List of corrections made by IMMA to TRANS/WP.29/GRPE/2004/11 (gtr text)

Figure 6-2: Equipment for sampling the gases and measuring their volume

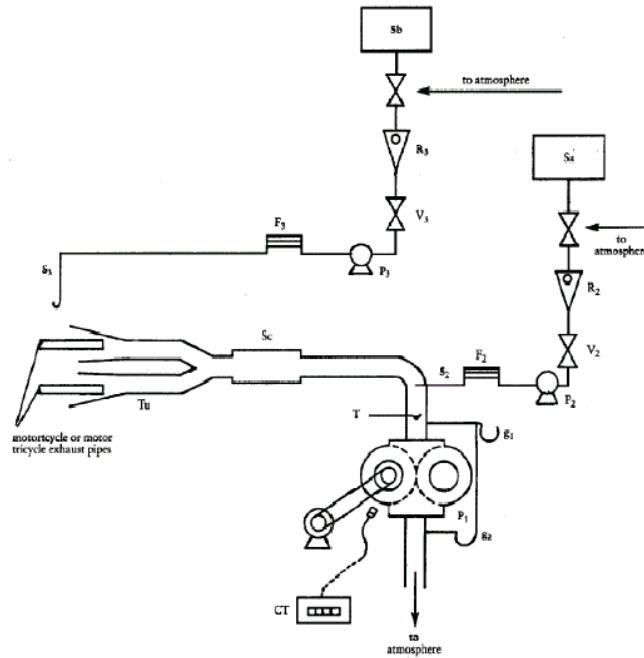
New 6.5.3 Exhaust gas measurement system

Add a new figure 6-2 as follows:

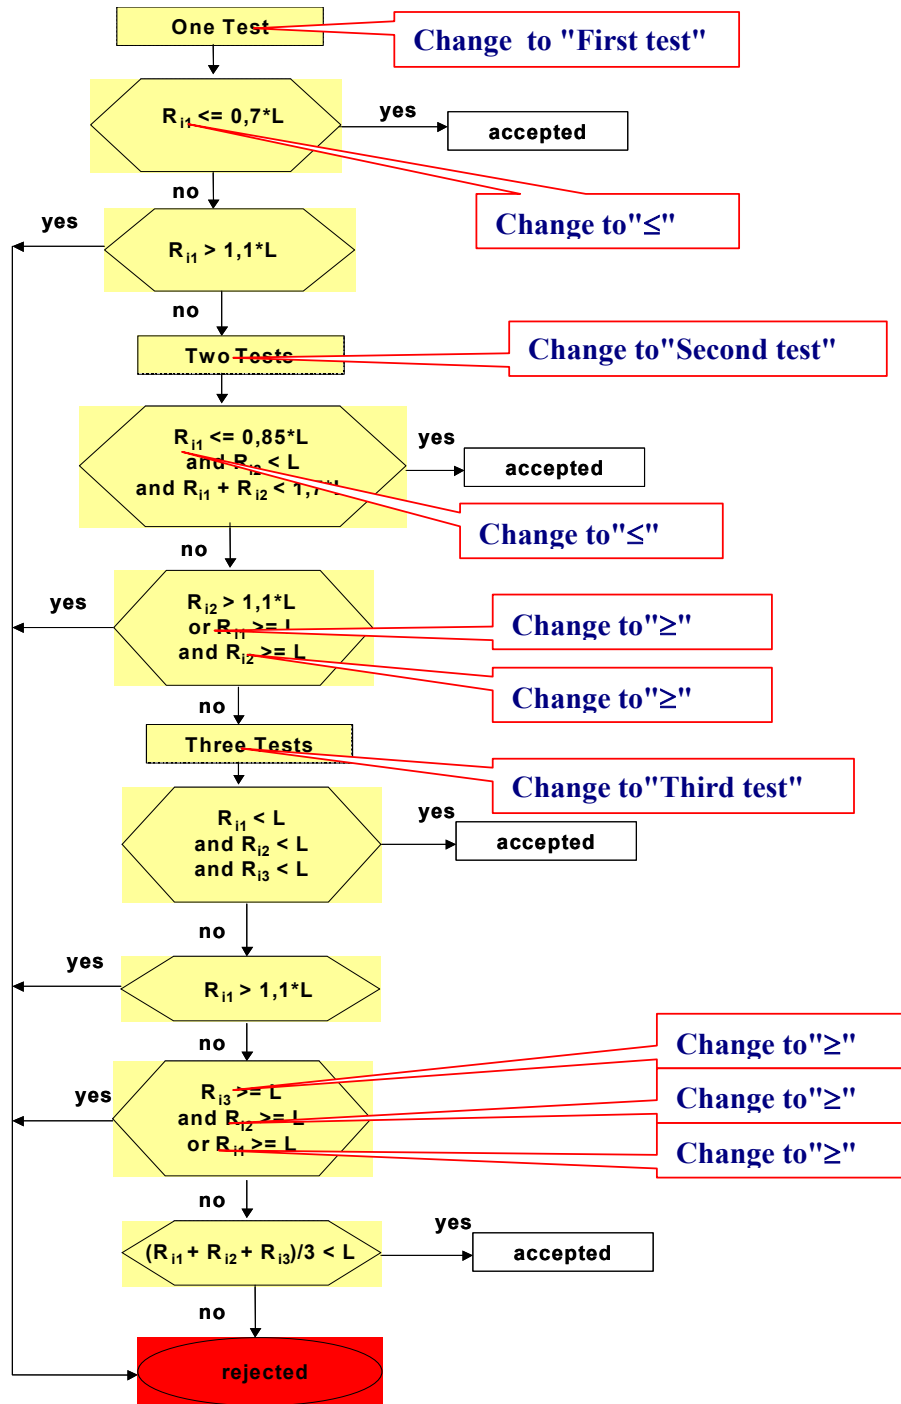
“The number of tests shall be determined as shown in figure 7-1. R_{i1} to R_{i3} describe the final measurement results for **the first (No.1) test to the third (No.3) test** and the gaseous pollutant, the carbon dioxide emission or fuel consumption as defined in paragraph 8.1.1.6. L is the limit value as defined in paragraph 5.”

and correct Figure 7-1 as follows:

Figure X Comparison between WMTC cycles and In-use data for Idling time ratio

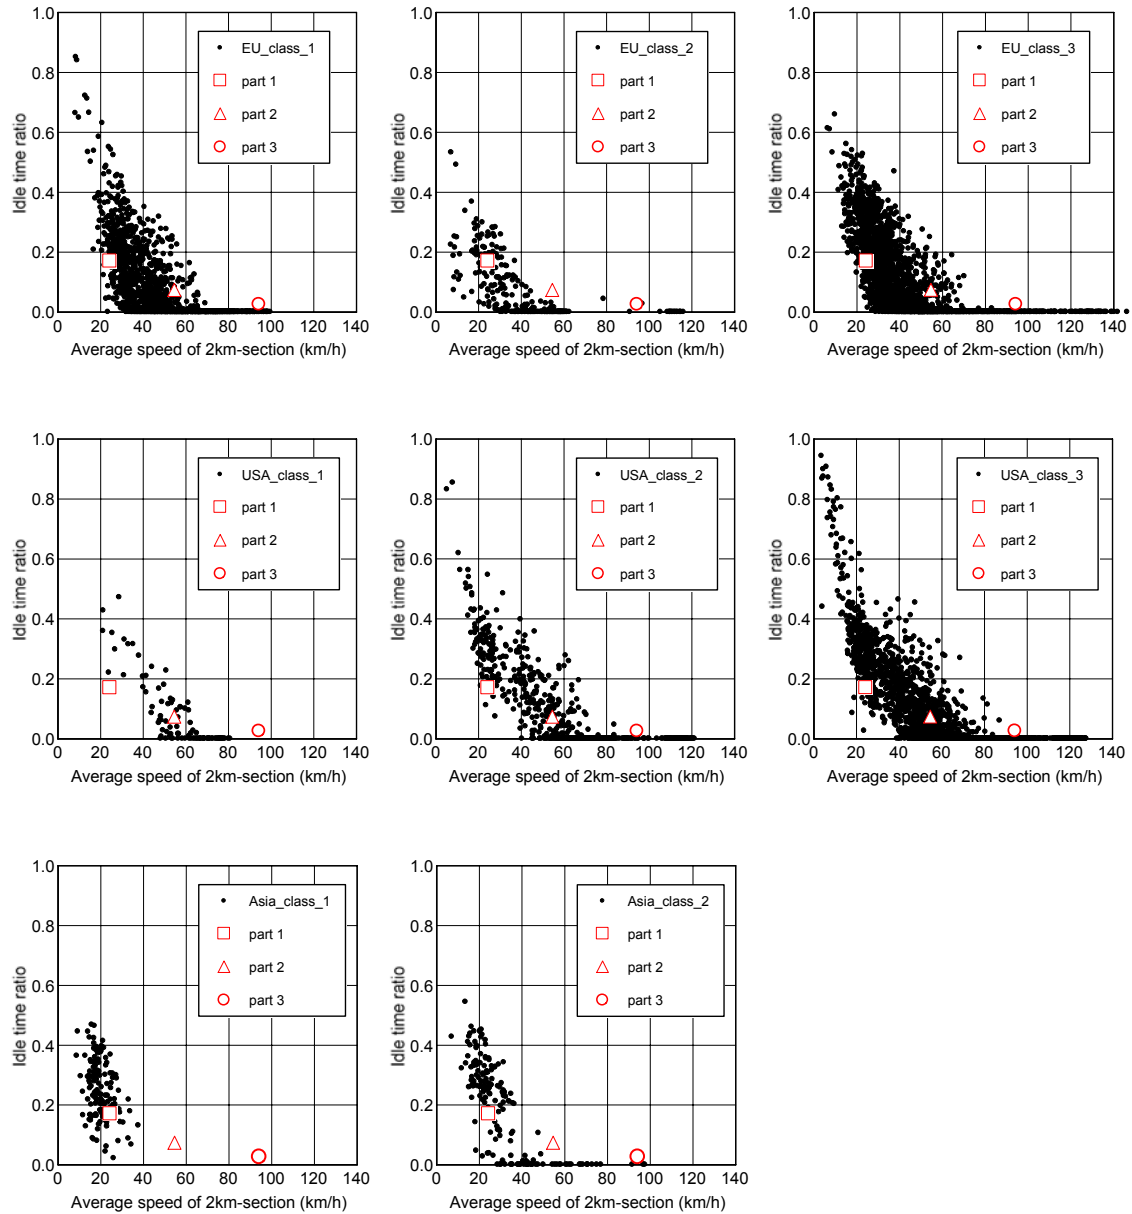
Insert after Table 16:

“JARI analysed the four-mode frequency (idling, acceleration, deceleration and cruising) in relation to the in-use data and the WMTC driving cycle, as summarised in the following tables.
